# HISTORIC AND DESIGN REVIEW COMMISSION

December 20, 2023

**HDRC CASE NO:** 2023-478  
**COMMON NAME:** 1304 E HOUSTON ST  
**LEGAL DESCRIPTION:** NCB 574 BLK B-13 LOT 31 MERCHANTS SUBD  
**ZONING:** D  
**CITY COUNCIL DIST.:** 2  
**APPLICANT:** Jeremy Jaramillo/TBA Douglas  
**OWNER:** Pat Kennedy Jr./TPB Merchants MM, LLC  
**TYPE OF WORK:** Construction of a 6-story parking structure  
**APPLICATION RECEIVED:** December 01, 2023  
**60-DAY REVIEW:** January 30, 2024  
**CASE MANAGER:** Edward Hall

The applicant is requesting a Certificate of Appropriateness for approval to construct a 6-level parking structure at 1304 E Houston Street. This property is located within the Downtown Design Guide area. The proposed new construction will be bounded to the north by E Houston, to the east and south by private property and to the west by Union Pacific railway tracks.

EXTERIOR  
ELEVATIONS

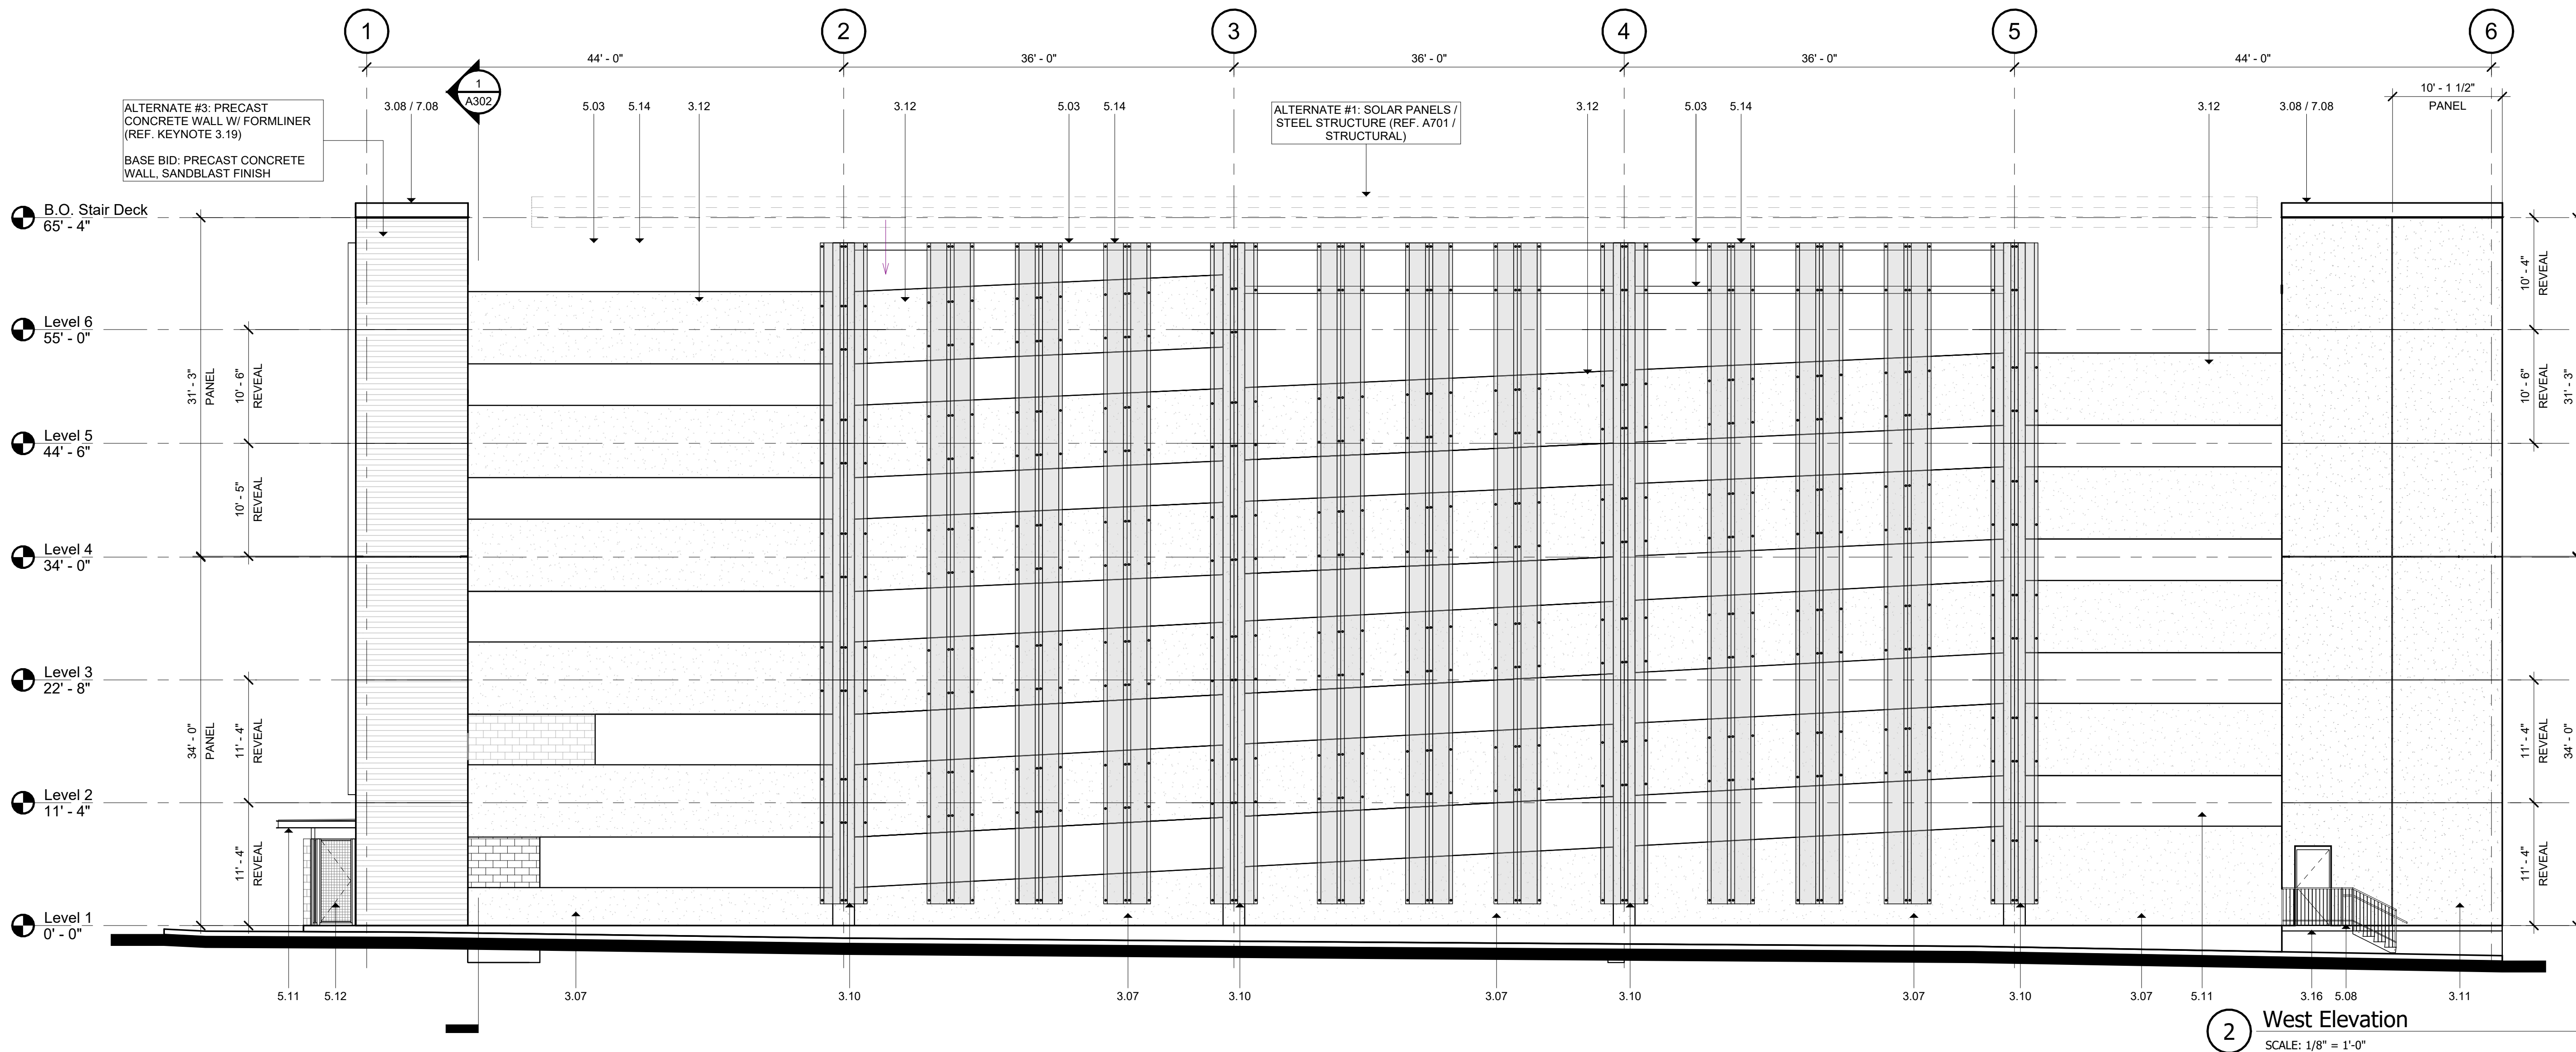
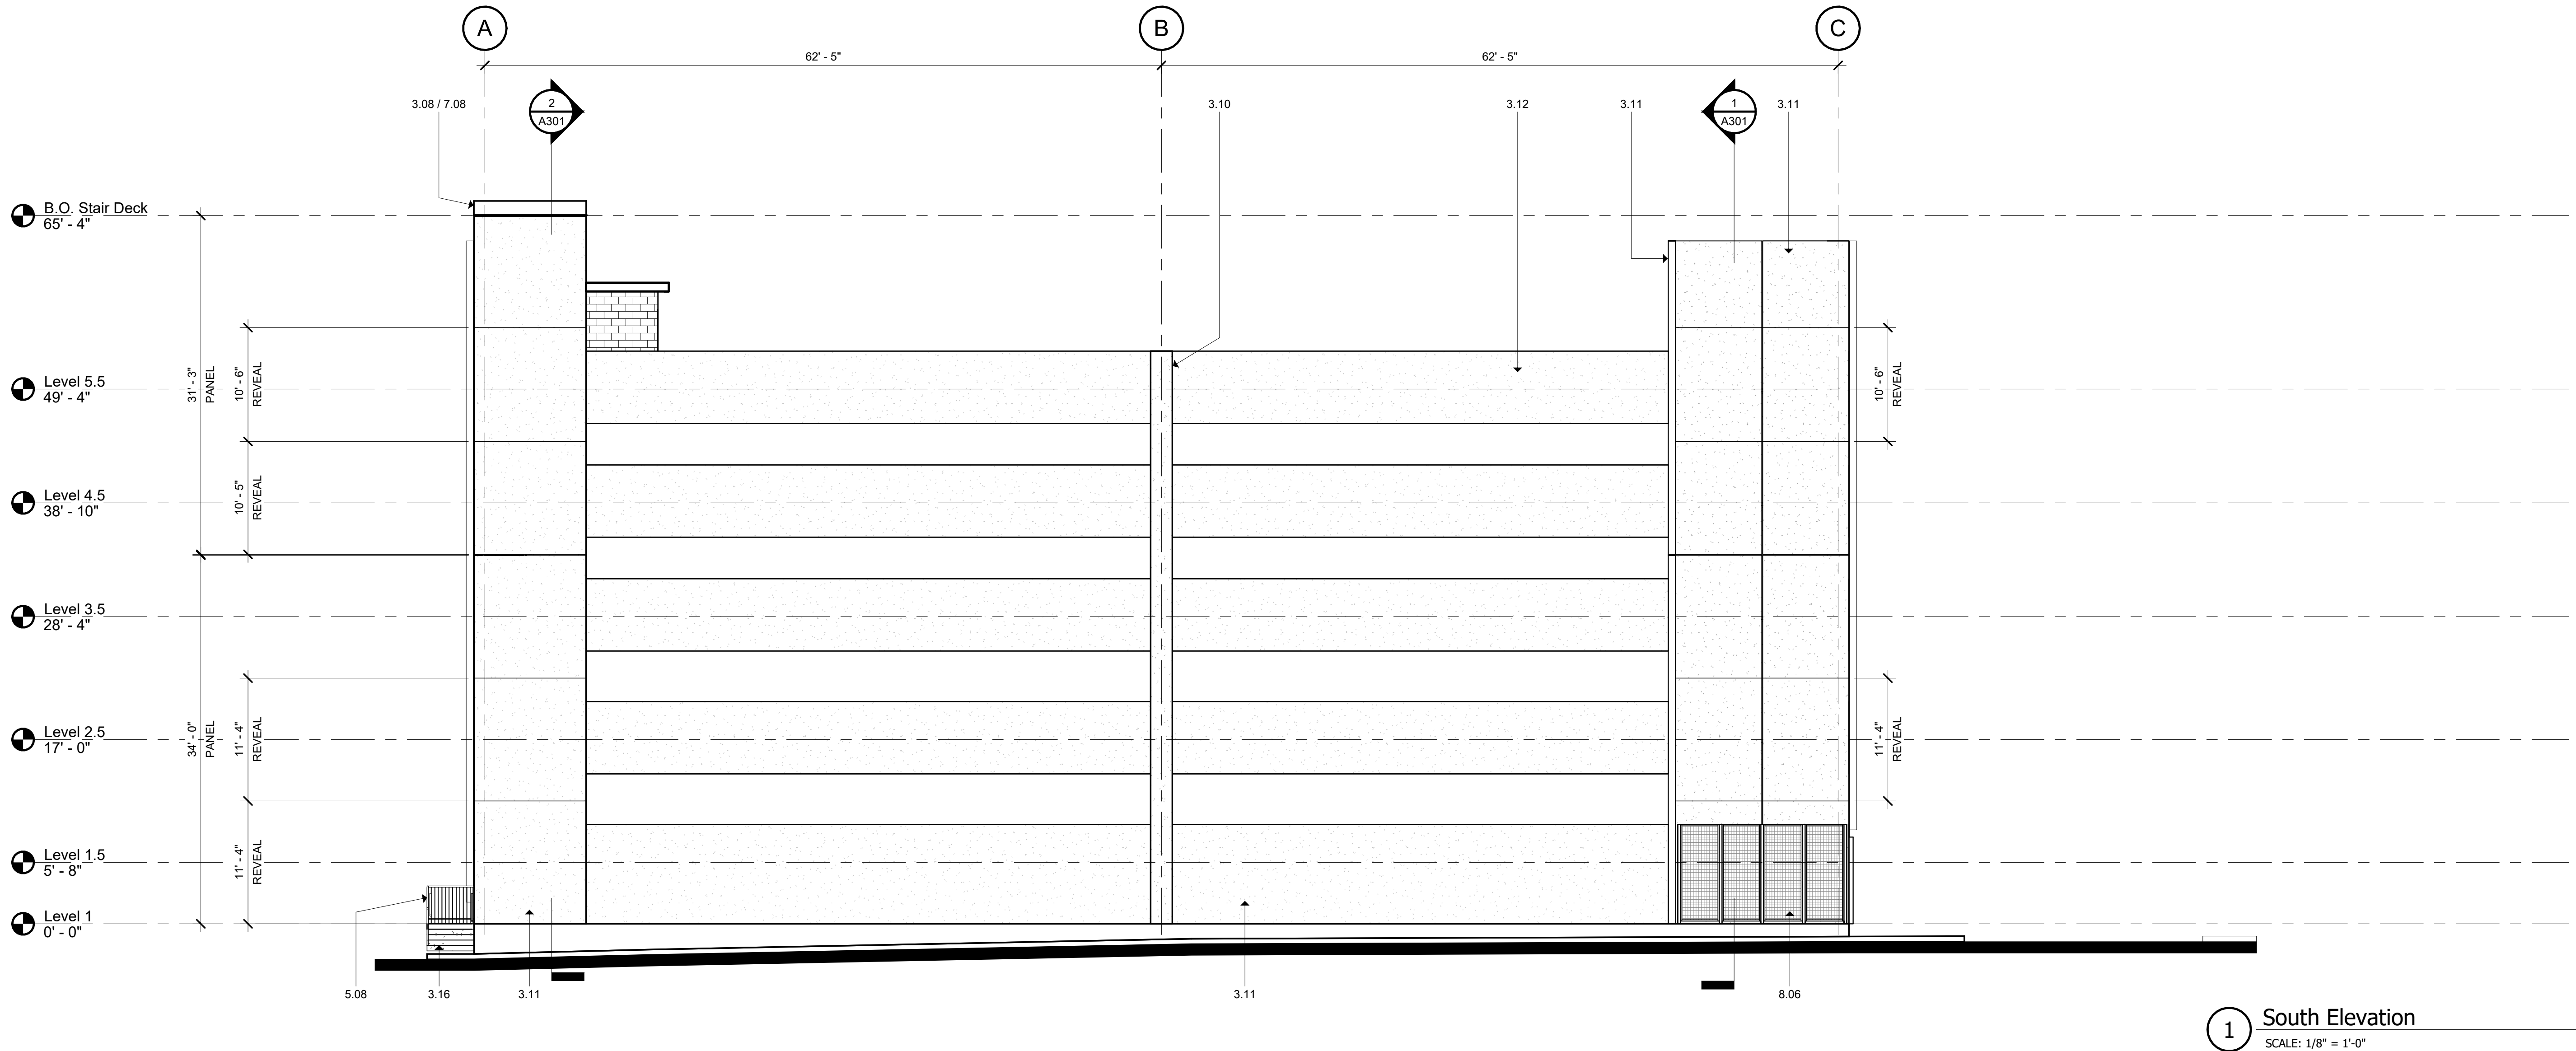
- i. That vertical façade elements be added to the complete length of each façade. ***This stipulation has not been met.***
  - ii. That the E Houston Street façade be fully designed to appear to feature active space at the ground level. Storefront systems should extend the E Houston Street façade, particularly beneath the proposed pedestrian canopy. An alternative solution would be to install evergreen street trees as a screening. ***This stipulation has not been met.***

- i. That vertical facade elements be added the complete length of each facade.  
Refer to A201 and A202 for updated elevations. The south facade is designed to accomodate future expansion of the garage.
